**CONWAY**  
HISTORIC DISTRICT COMMISSION  
STAFF REPORT

**5:30pm • March 26, 2018 • City Hall**

**C1 DUPLEX REMODEL - 825/827 FAULKNER STREET**

# D1 NEW CARPORT & BACK PORCH - 537/539 OLIVER STREET

East Elevation

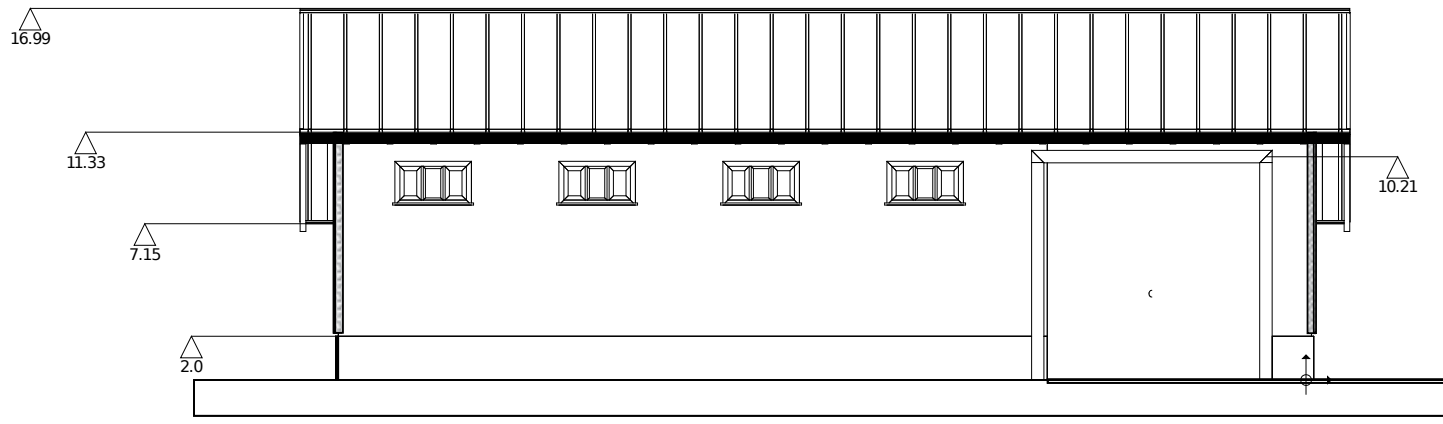
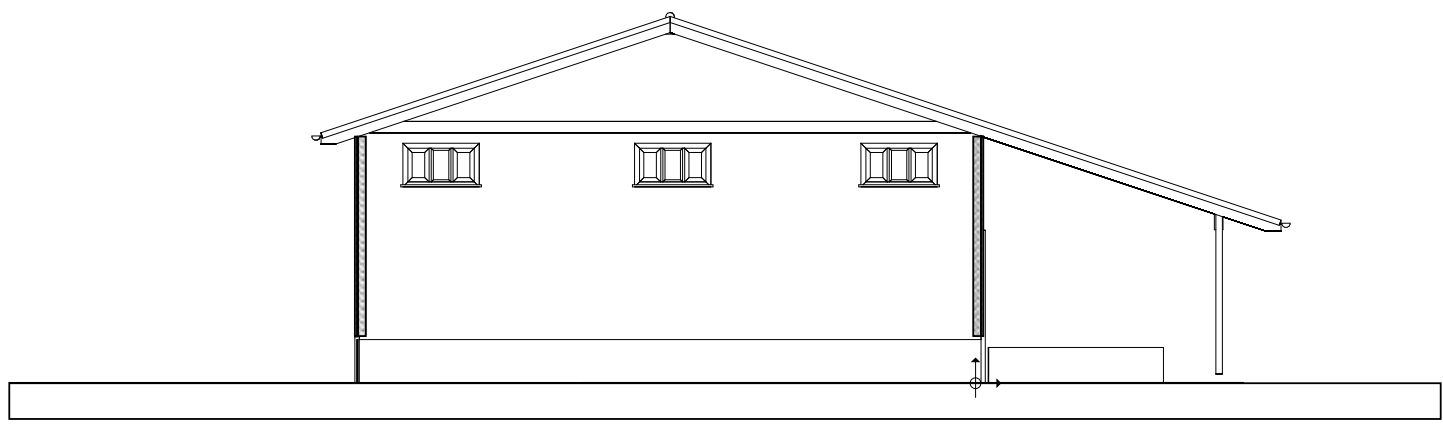
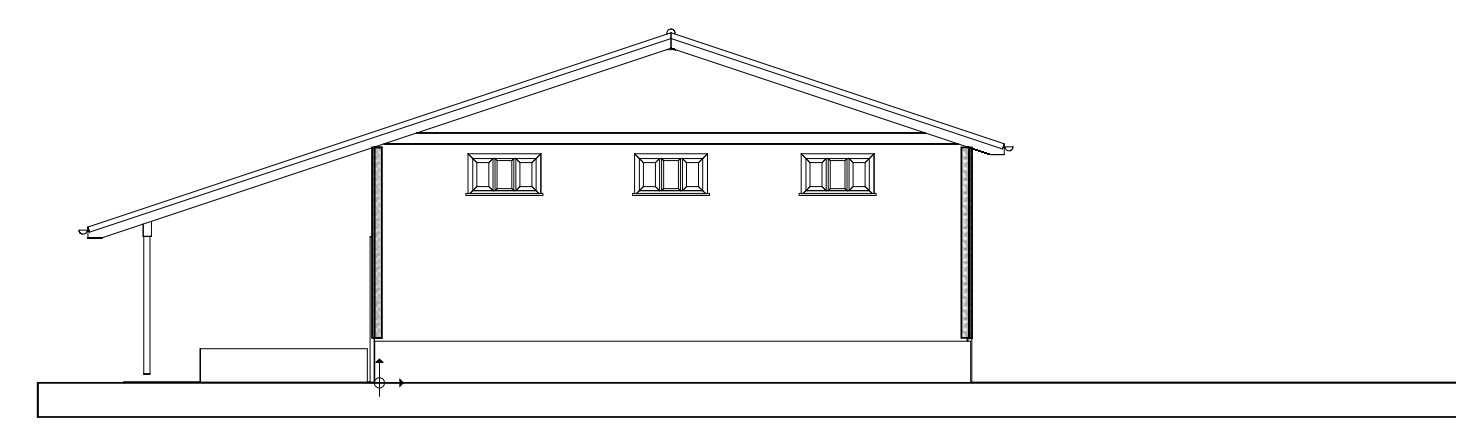
**Doors and windows.** The size and proportion, or the ratio of width to height of window and door openings of new buildings' primary facades should be similar and compatible with those on facades of surrounding historic homes. Clerestory painted PVC trim windows are planned on 3 elevations. A vinyl garage door is shown on the west (rear) elevation. A large 10' x 10' garage door is shown on the front facade.

Siding is planned to be Triple 3 smooth finish vinyl. Composite board will be used on corners.

**Roof.** The roof is described as trapezoidal metal 24 gauge. The OCDOD standards state, "Metal roofing is generally prohibited, but applicants may use after proving historical value for a given project." There are several structures in the area that have metal roofs.

- HDC Staff recommends approval of the shop structure with the following conditions:
1. Setbacks - The structure's proposed setbacks measured approximately from the property line: East - 17.5 feet, North 20 feet, South 10 feet, and West 100 feet+ are appropriate.
  2. Due to the size of the lot, the outbuilding's approximate 1760 square feet under roof shall be allowed.
  3. Triple 3 smooth finish vinyl siding shall be allowed.
  4. Metal roof shall be allowed.
  5. HVAC and utility equipment shall be screened and located on side or rear elevations.
  6. Sidewalk in-lieu fee of \$588 may be payed in-lieu of sidewalk construction.
